Delegated Report

Planning Application No: 20211311

Location: Land At Market Square And Horn Yard Car Parks New Swan Yard
Gravesend DA12 2EN

Description: Application for approval of condition 28 attached to planning permission reference number 20200343 relating to details of balconies and balustrades.

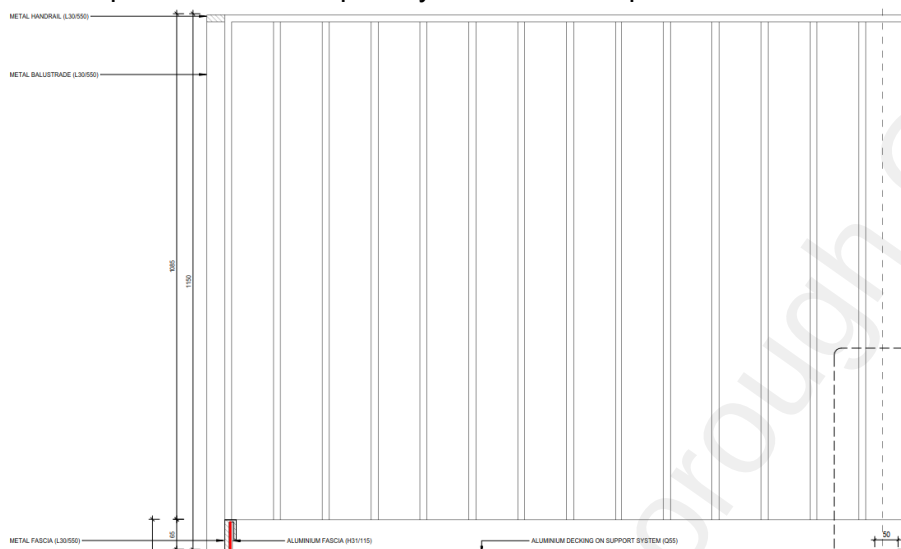
As the plans show the balconies are 1.15m high with a distance on of 0.09m between each vertical railing which will provide a level of privacy for future occupiers. Below is an extract showing typical balcony details.

I have concern with the balconies as proposed would not provide privacy for future occupiers. A way in which this could be addressed is through glazing with which is obscured for the balconies. I look forward to your thoughts on this.

They appreciate your concerns, but need to respond to the market in terms of balcony design.

Reef propose to control “balcony screening” through the residential management system (e.g. tenant handbooks and close monitoring) to ensure tenants don’t install bamboo or other random screening.

It is considered that as the planning approval specifically included vertical railings on the balconies and the space between each rail is 0.01m sufficient privacy is provided for future occupiers.
